## Eight Discipline Report (8D Report)

To: <b>Customer</b>	8D report No.:
From: : <b>Chicony Power Technology</b>	RMA claim No.:
CC :	Chicony Power P/N: <b>A035R004L</b>
	Customer P/N:
Submit date: <b>2014/09/04</b>	Product description: <b>Adapter 35W</b>
Receive date: <b>2014/09/01</b>	Defect D/C or Lot No.: <b>140628</b>
<b>Subject : Drop test fail 3pcs units(5 , 6, 7) , 由於 PCB &amp; T1 及 CASE 未固定好, 造成有元件損毀, 因此 Drop test 後發生有異音、failed hipot、輸出無法正常切換的問題。</b>

#### 1. S/N:140628003BC7

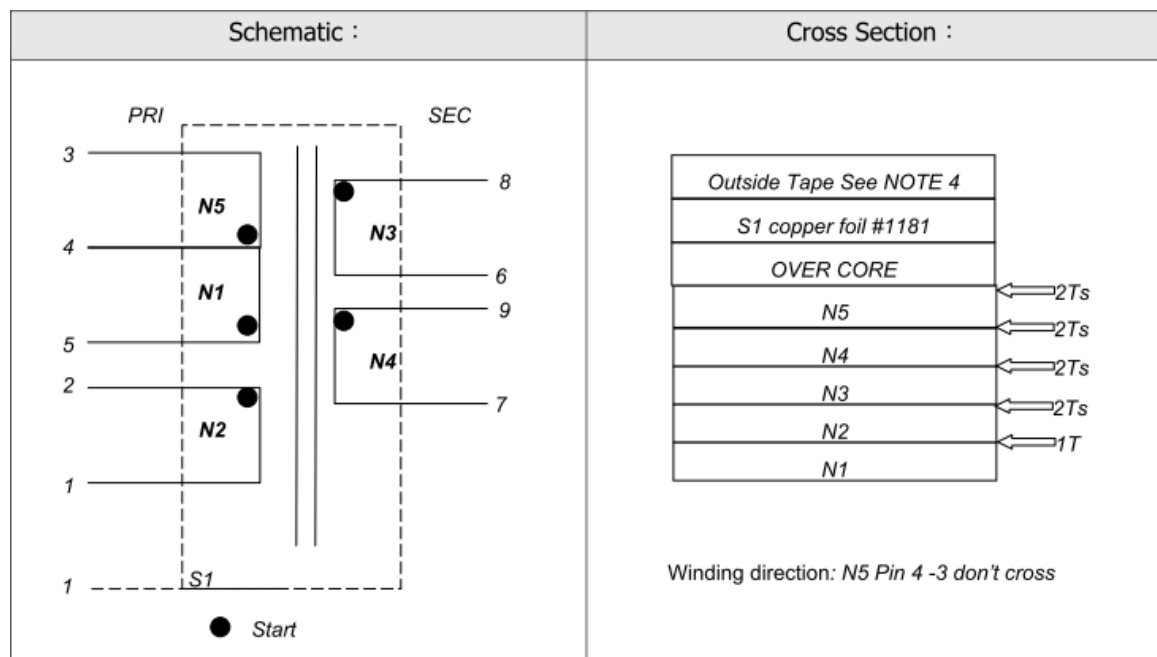
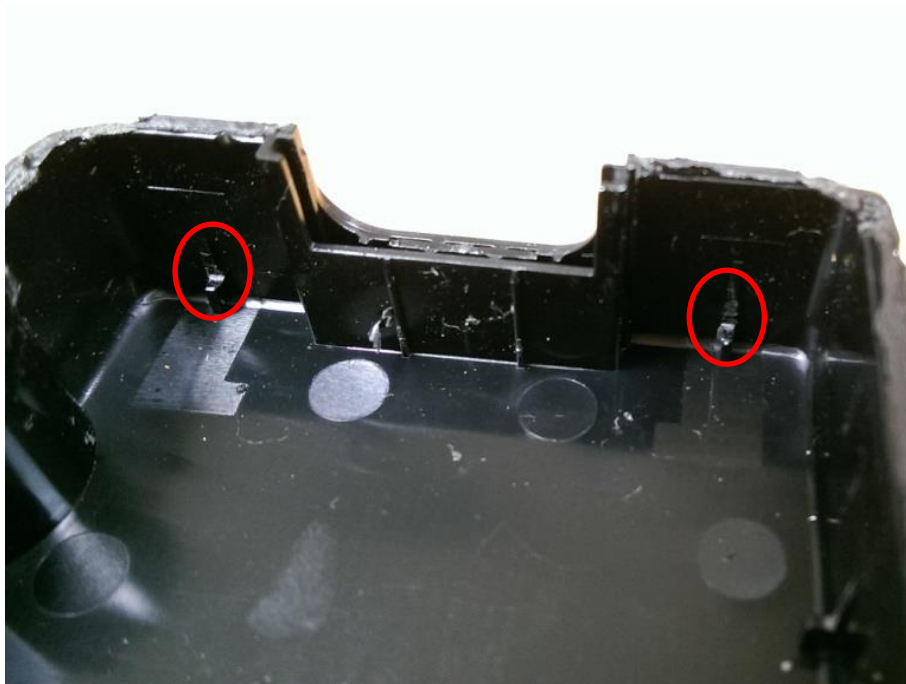
After open the case, we observed the transformer bobbin was broken and the secondary winding (N4) of transformer had snapped. The copper shield (S1) is soldered to pin 1 and pin 1 is connected in primary side ground. The copper shield (S1) is pasted on the core so the transformer core was defined primary side then if the triple wire of secondary snapped, it will cause arc due to the insulation of triple wire was broken (insulation is insufficient). We found the root cause of hi-pot was an arc between copper and the secondary winding of transformer during the hi-pot test. The secondary windings (N3 and N4) are connected in parallel thus there is still output even if one winding is broken.

The transformer schematic as below:

The slot to hold the PCB are cracked on the chassis, and the PCB cannot be fixed in the case. It's the reason why the unit is rattled.

## 2. S/N:140628003CC7

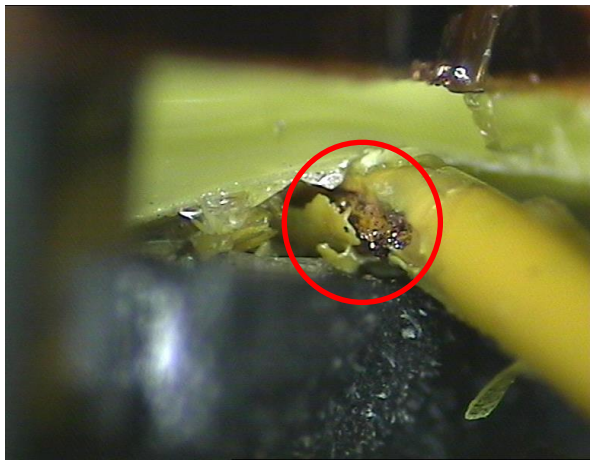
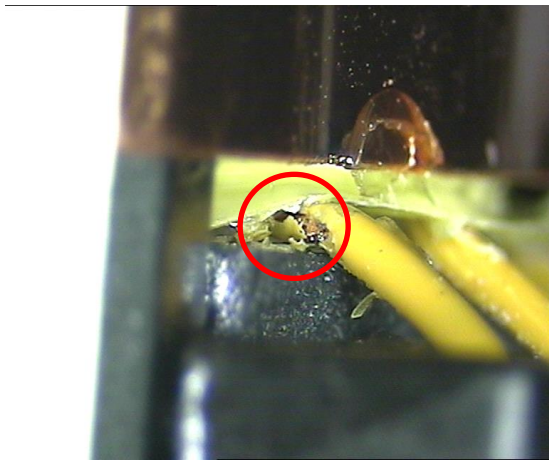
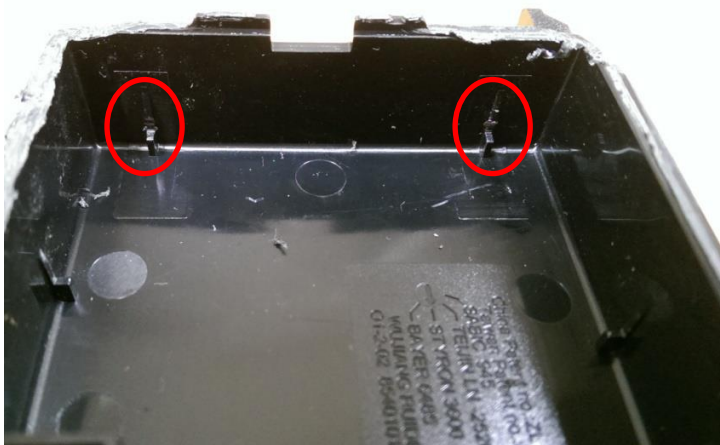
After open the case, we observed the transformer bobbin was broken and triple wire winding (N3) was breakage. The copper shield (S1) is soldered to pin 1 and pin 1 is connected in primary side ground. The copper shield (S1) is pasted on the core so the transformer core was defined primary side then if the triple wire of secondary was breakage, it will cause arc due to the insulation of triple wire was broken (insulation is insufficient). We found the root cause of hi-pot was an arc between copper and the secondary winding of transformer during the hi-pot test.

The slot to hold the PCB are cracked on the chassis, and the PCB cannot be fixed in the case. It's the reason why the unit is rattled.

### 3. S/N:140628003DC7

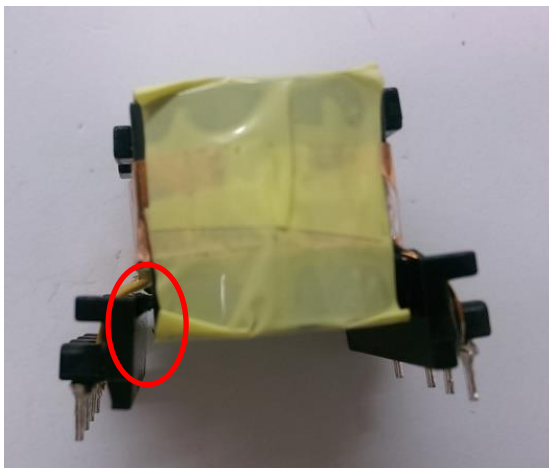
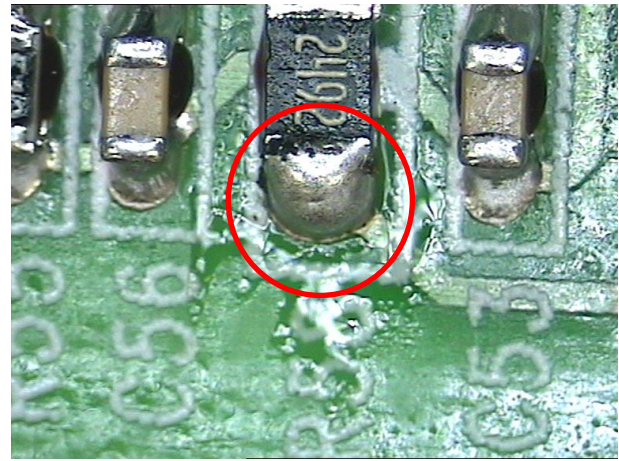
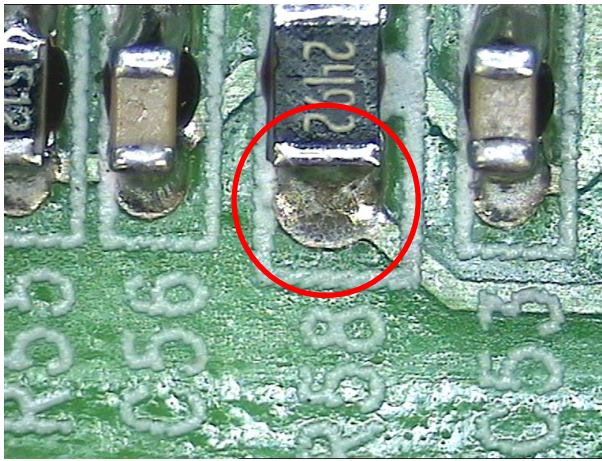
We checked the Hi-pot test and the result is passed. The output voltage was 12V only.

After open the case, we observed the transformer bobbin was broken and the R58 may has cold soldering after drop test. The output voltage was normal 32V after we re-welded the R58.

Before re-welded

after re-welded
